**Project: IEEE P802.15 Working Group for Wireless Personal Area Networks (WPANs)**

**Submission Title:** Proposed OFDM Resolutions for Comments of CIDs 400 through 416 of LB #87

**Date Submitted:** March, 2013

# CID 402, 20.2.3.4, 73, 6

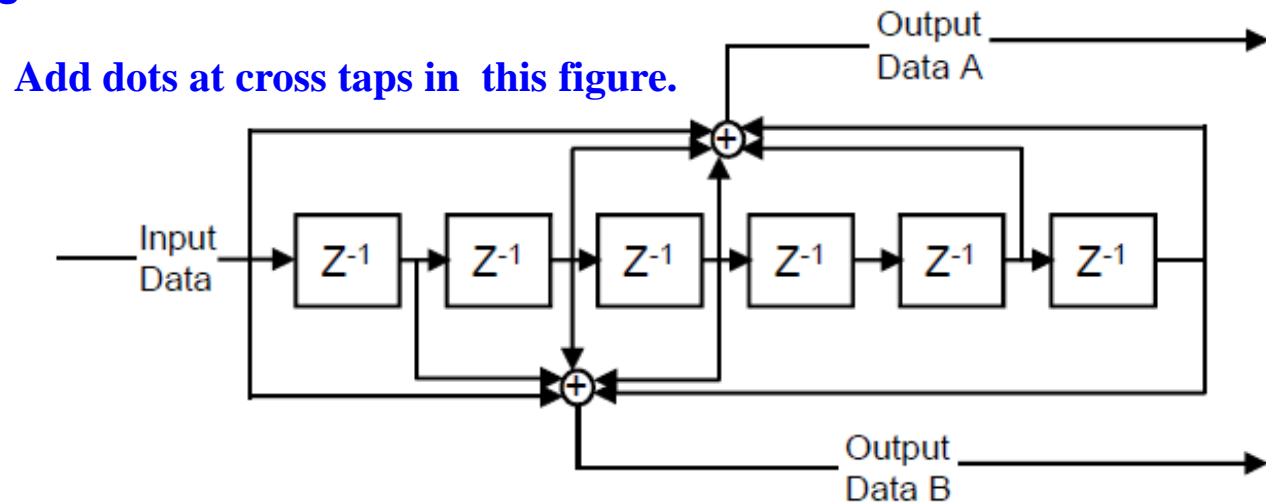
- Comment
  - Editorial: Figure 121 missing connections at taps in diagram.
- Proposed Change
  - Add connection dots or squares at cross taps. Do the same for other polynomial diagrams/figure throughout the draft.
- Proposed Resolution

*Modify Figure 121.*
